# RENESAS TECHNICAL UPDATE

Product Category	MPU/MCU		Document No.	TN-RX*-A0243A/E	Rev.	1.00
Title	Errata to the Section on Electrical Characteristics in the User's Manuals for the RX72M and RX72N Groups		Information Category	Technical Notification		
Applicable Product	RX72M Group, RX72N Group	Lot No.	Reference Document	RX72M Group User's Manual: Hardware Rev.1.00 (R01UH0804EJ0100) RX72N Group User's Manual: Hardware Rev.1.00 (R01UH0824EJ0100)		
		All

This document describes corrections to the section on Electrical Characteristics in the User's Manual: Hardware, Rev.1.00 for the applicable products stated above. Page, table, and figure numbers are based on the manual for the RX72M Group. Refer to the table on the last page of this update for the corresponding page, table, and figure numbers in the manual for the RX72N Group.

**Figure 65.41 MTU Clock Input Timing**

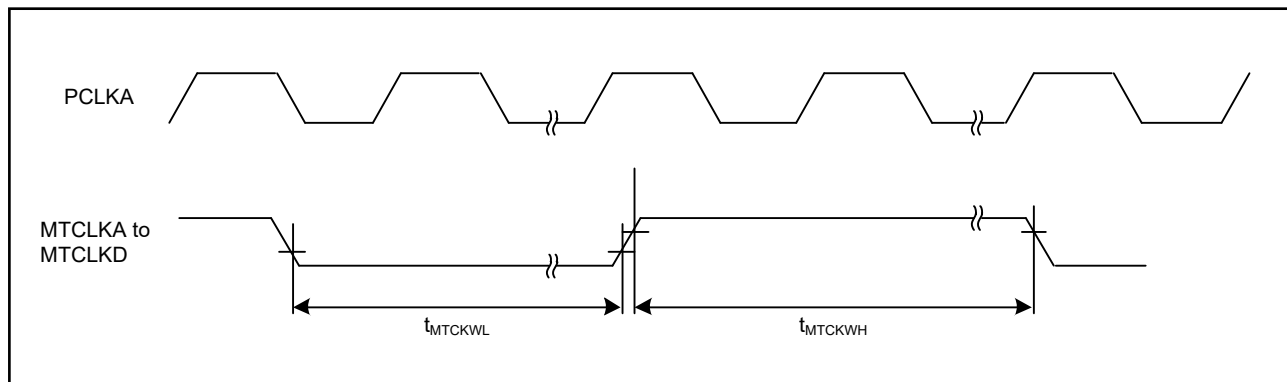
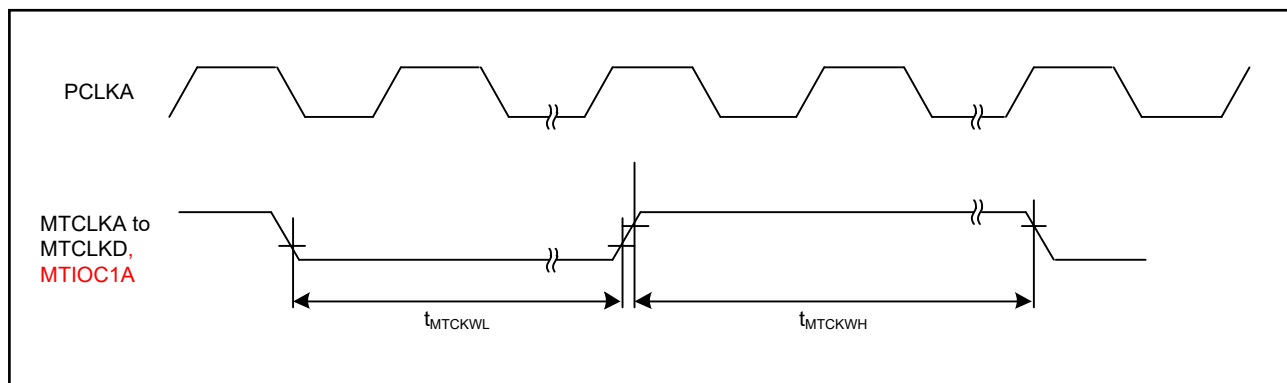
The MTIOC1A pin is added to Figure 65.41, MTU Clock Input Timing as follows.

**Figure 65.51 Output Disable Time of POEG in Response to the Oscillation Stop Detection**

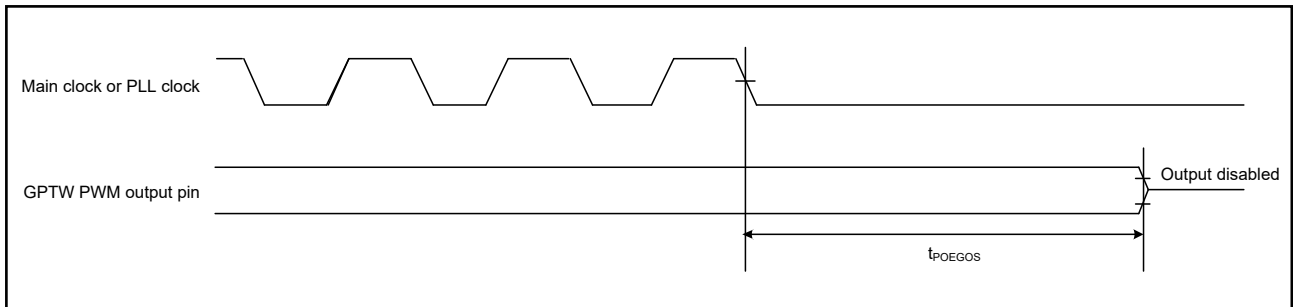
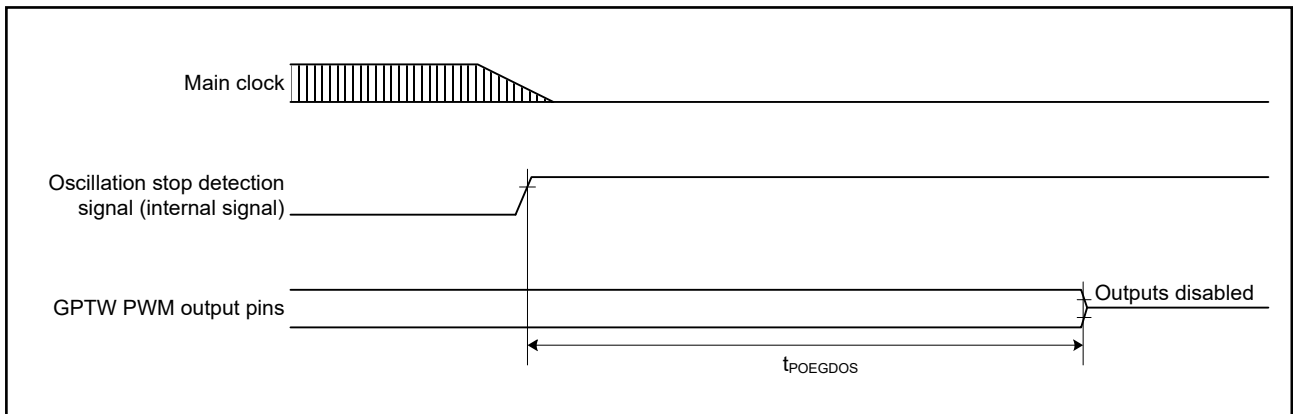
Figure 65.51, Output Disable Time of POEG in Response to the Oscillation Stop Detection is corrected as follows.

**Figure 65.xx Simple IIC Bus Interface Input/Output Timing**

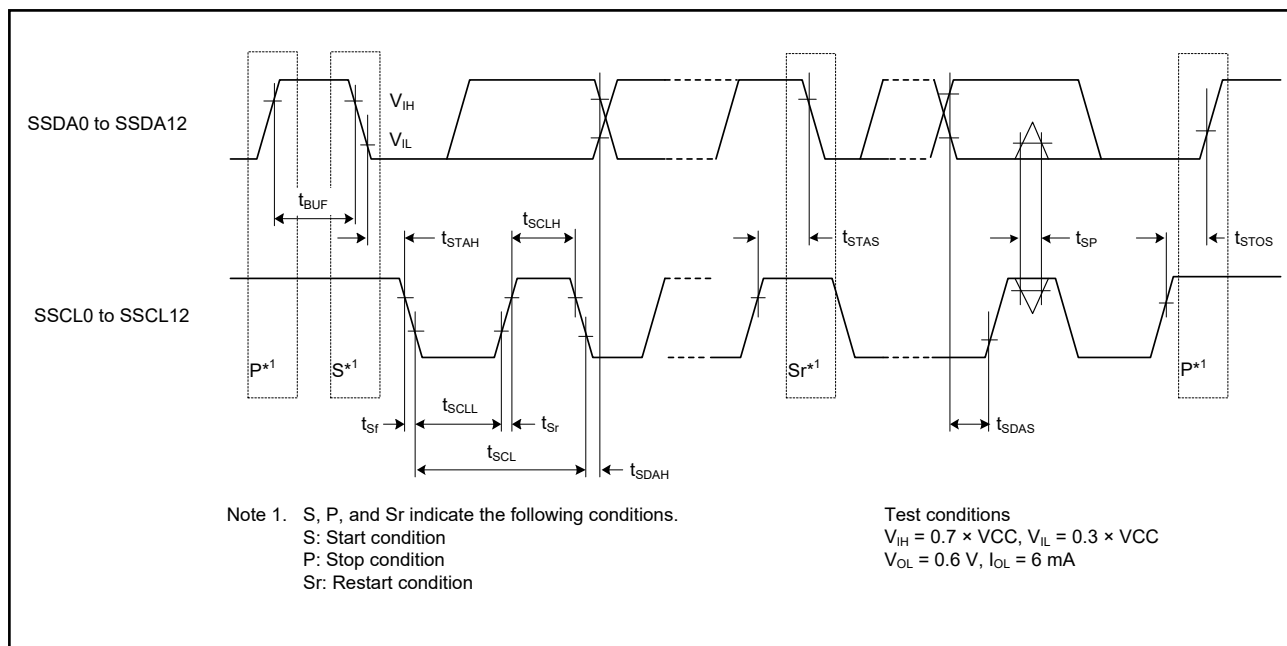
The following figure is added to illustrate the input and output timing of the simple IIC bus interface.
